PLANNING COMMITTEE - 9th December 2025

Proposal Description: Demolition of the existing dwelling and construction of two new dwellings, and creation of a new vehicular access (Amended Plans/ Amended Title).

At: Holmfield, Ankerbold Road, Old Tupton, Chesterfield, S42 6BX

Site Levels (existing and proposed)

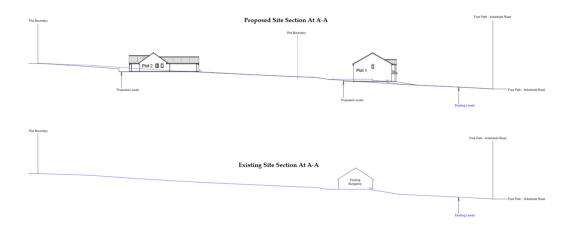
- 7.29 Having initially applied the 25 degree rule, Officers estimated that the proposed ridge level of the south facing gable elevation of the main element of the bungalow would very marginally fail to accord with the 25 degree rule, with the ridge of the gable measuring approximately 26 degrees from the centre of the north facing ground floor openings at the nearest properties on Church View Drive (these being numbers 25 and 27). Officers estimates suggest that the rest of the south facing elevation of the proposed bungalow (including the entirety of the front projecting gable) would comfortably be in accordance with the 25 degree rule.

- 7.32 In the interests of seeking a further betterment of the relationship between the proposed bungalow and properties on Church View Drive, Officers broached the marginal non-compliance with the 25 degree rule with the applicant's agent.

7.33 Following discussions with the applicant's agent, Officers understand that a reduction in the finished floor levels of the proposed bungalow, by approximately 500m, would ensure full compliance with the 25 degree rule. For information, the relevant extracts from the revised drawing are included below; these images detail the 25 degree rule applied to the most affected property on Church View Drive (number 27) and a sectional drawing showing how the proposed bungalow would be dug in to the existing land levels, thereby reducing its impact:

- 7.35 Officers consider that a planning condition relating to finished levels for Plot 2 would therefore allow control of this matter, ensuring that the impact of the proposed development on the amenity levels of the occupiers of properties on Church View Drive would be further minimised, ultimately as a consequence it being fully in accord with 25 degree rule.
